RESOLUTION NO. 2014-R-03

RESOLUTION OF THE METRO GOLD LINE FOOTHILL EXTENSION CONSTRUCTION AUTHORITY, ADOPTING AN ADDENDUM PURSUANT TO THE CALIFORNIA ENVIRONMENTAL QUALITY ACT AND APPROVING PROJECT REFINEMENTS RELATED TO PHASE 2B OF THE GOLD LINE FOOTHILL EXTENSION, FROM AZUSA TO MONTCLAIR, INCLUDING A BRIDGE CROSSING AT GAREY AVENUE AND RELOCATION OF THE POMONA STATION

Addendum No. 1

**Analyzing a Grade-Separated Crossing at Garey Avenue and a Shift
in the Location of the Pomona Station Platform**

Figure 1. Plan and Profile of Bridge at Garey Avenue

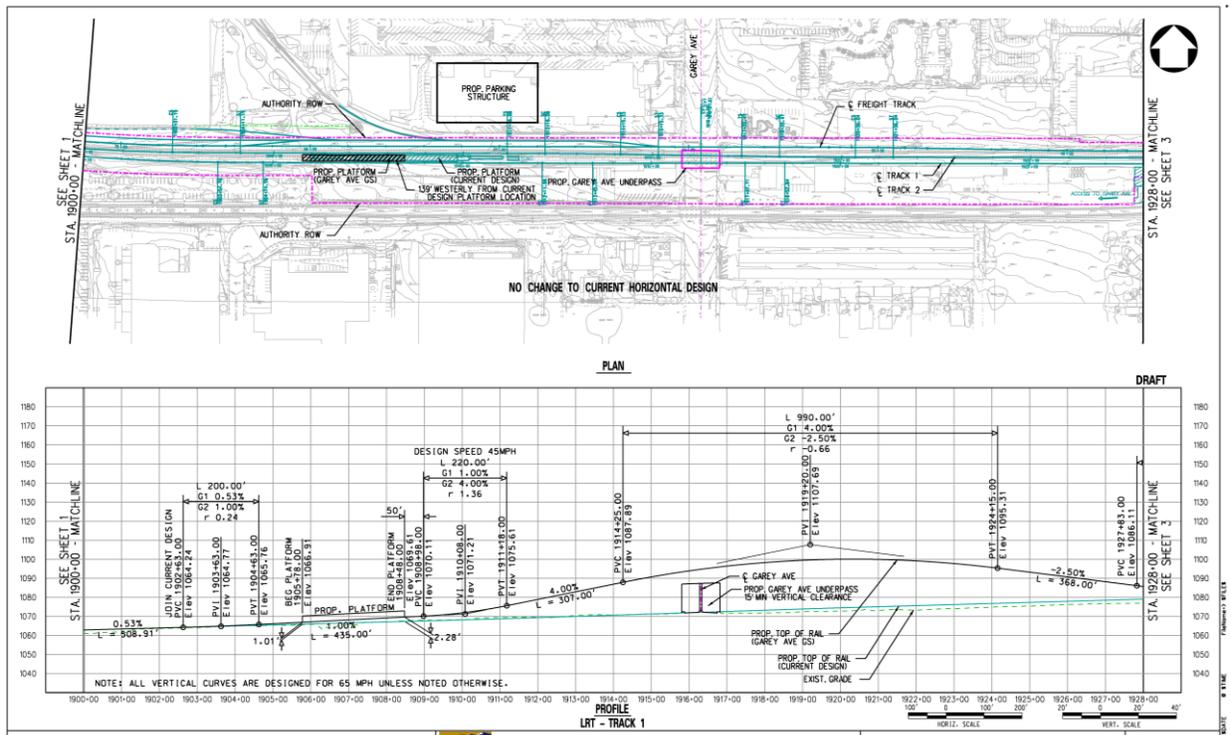
The Authority has analyzed the potential refinement of the track alignment design to include an LRT bridge at Garey Avenue, which would address concerns of the City of Pomona about an at-grade crossing at this location. The length of the grade separation from end to end would be approximately 2,300 feet—spanning from just east of the adjusted station platform to a point approximately 1,500 feet east of Garey Avenue.

Adhering to California Manual on Uniform Traffic Control Devices (MUCTD) standards, the roadway clearance (for vehicles) for the Garey Avenue road below the bridge would be 15 feet and 6 inches.

At Garey Avenue, the bridge would be approximately 27 feet tall at the highest point as measured from the roadway to the top of the barrier, the highest most visible permanent element of the structure. The overhead catenary system (OCS), i.e., the electric wires that power the train and the poles that suspend them, are between 19 and 21 feet above the top of rail. OCS poles, normally spaced 130-140 feet apart, are 24 feet in total height.

Figure 1 shows the plans depicting both the platform location considered in the Final EIR (in green) and the proposed platform location refinement (in black).

Figure 1: Plan and Profile of Garey Avenue LRT Bridge (Page 1)

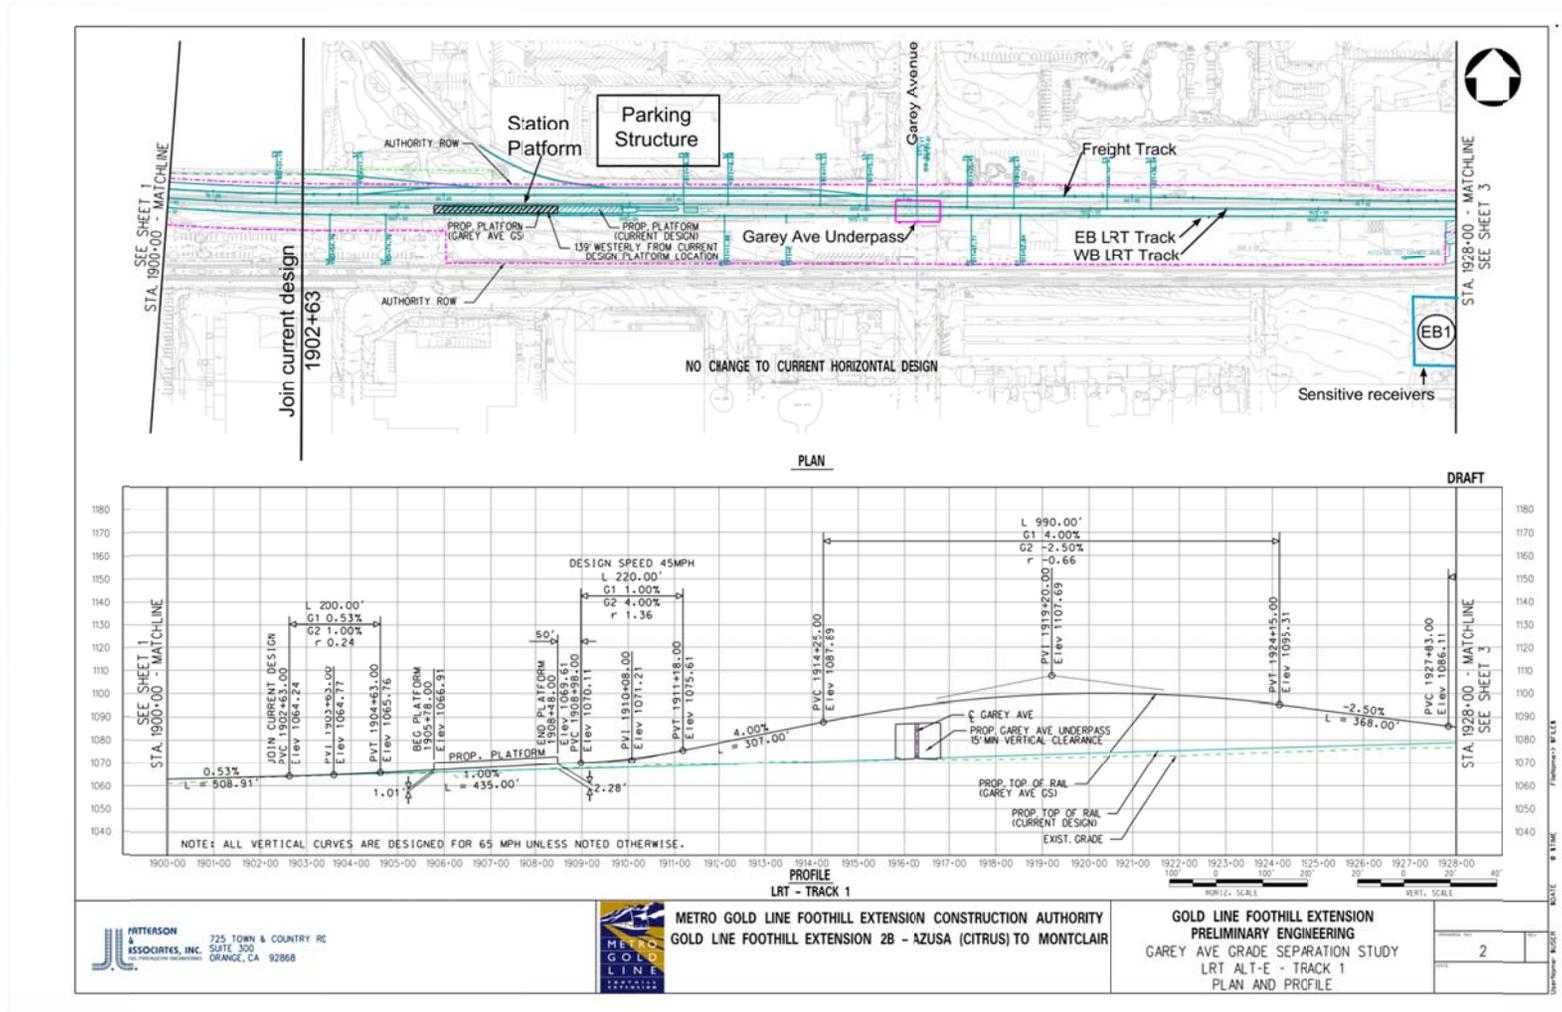
The incorporation of the LRT bridge will not change the horizontal distance from the sensitive receivers to the LRT tracks or the LRV speed. The track type on the LRT bridge structure will be ballast-and-tie,

the same track-type as the at-grade design. However, the tracks will be on the LRT bridge structure and vibration levels are about 10 dB lower for LRT track on an elevated structure.

Figure 2: Plan and Profile of Garey Avenue LRT Bridge (Page 2)

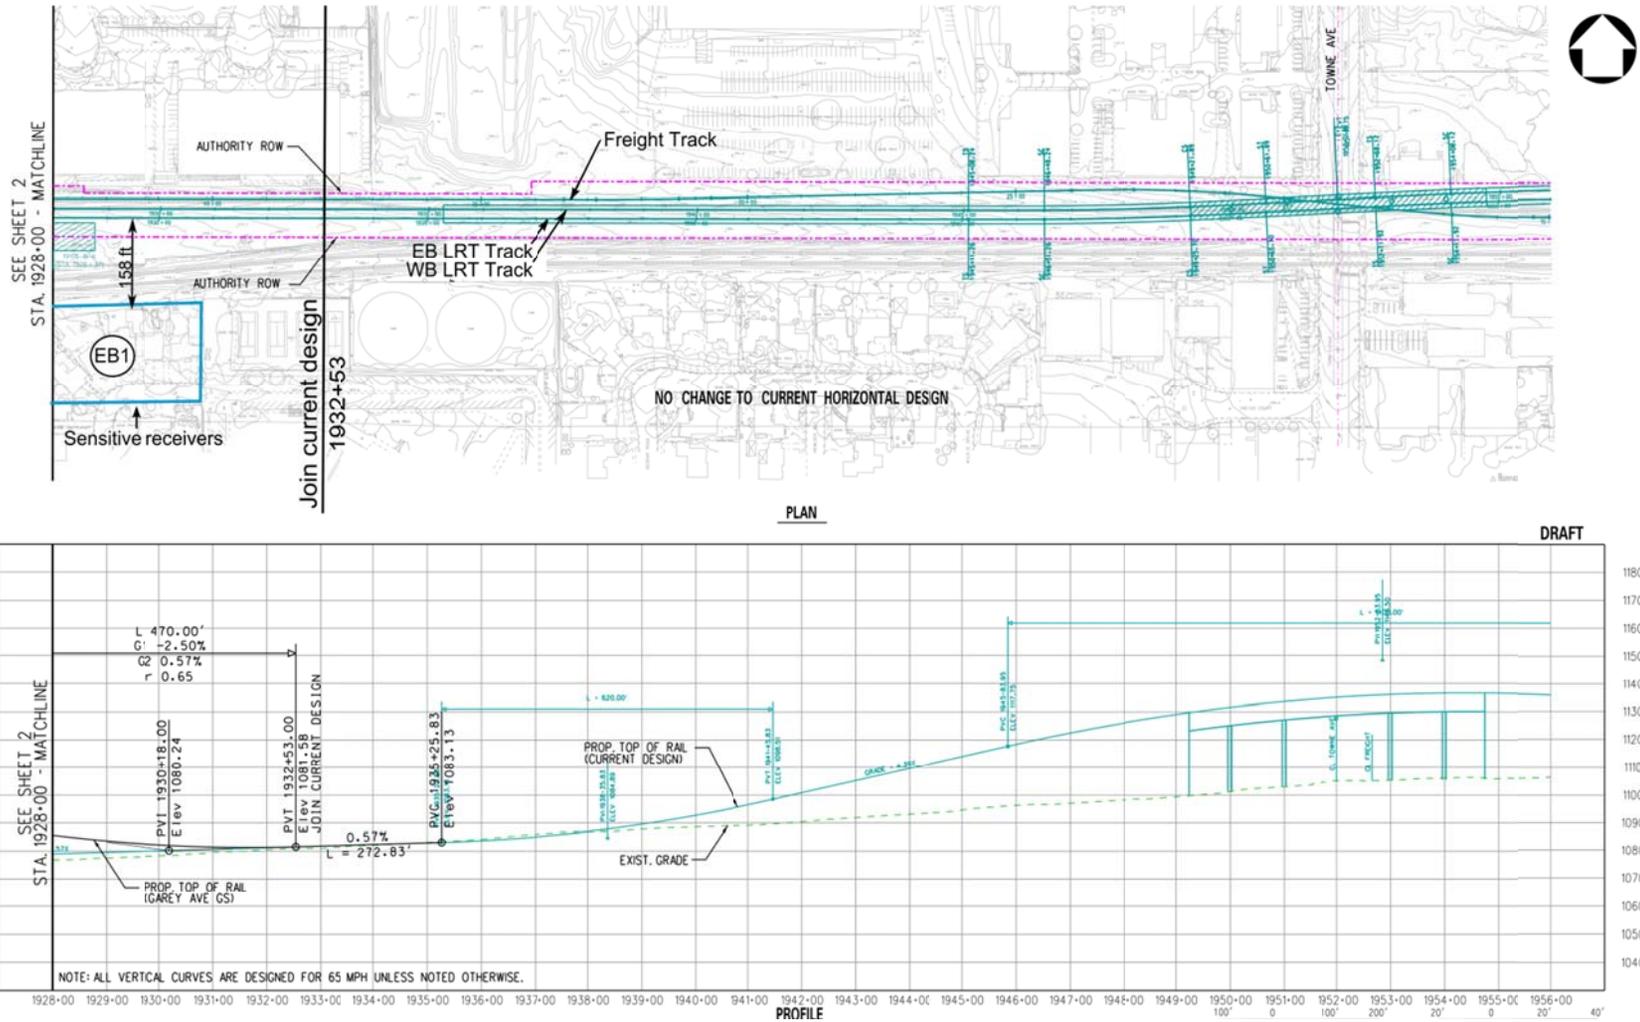
The incorporation of the LRT bridge will result in a vertical change in the track location, but will not result in a horizontal change in the track location. The incorporation of the LRT bridge will also result in a shift of a proposed station platform farther west. The sensitive receivers near the proposed LRT bridge (cluster EB1 in Pomona) are located at the east end of the bridge, where the proposed top of rail will be about 5 feet higher than the proposed top of rail for the Final EIR project. The 5 foot elevation difference does not result in a change in the predicted noise or vibration levels. The predicted noise and vibration levels for both the Final EIR Project and Addendum Project are shown in Table 4. There are no sensitive receivers near the proposed platform for the Final EIR project or for the LRT bridge project, so the shift in the platform location will not result in any changes to the noise or vibration analysis.
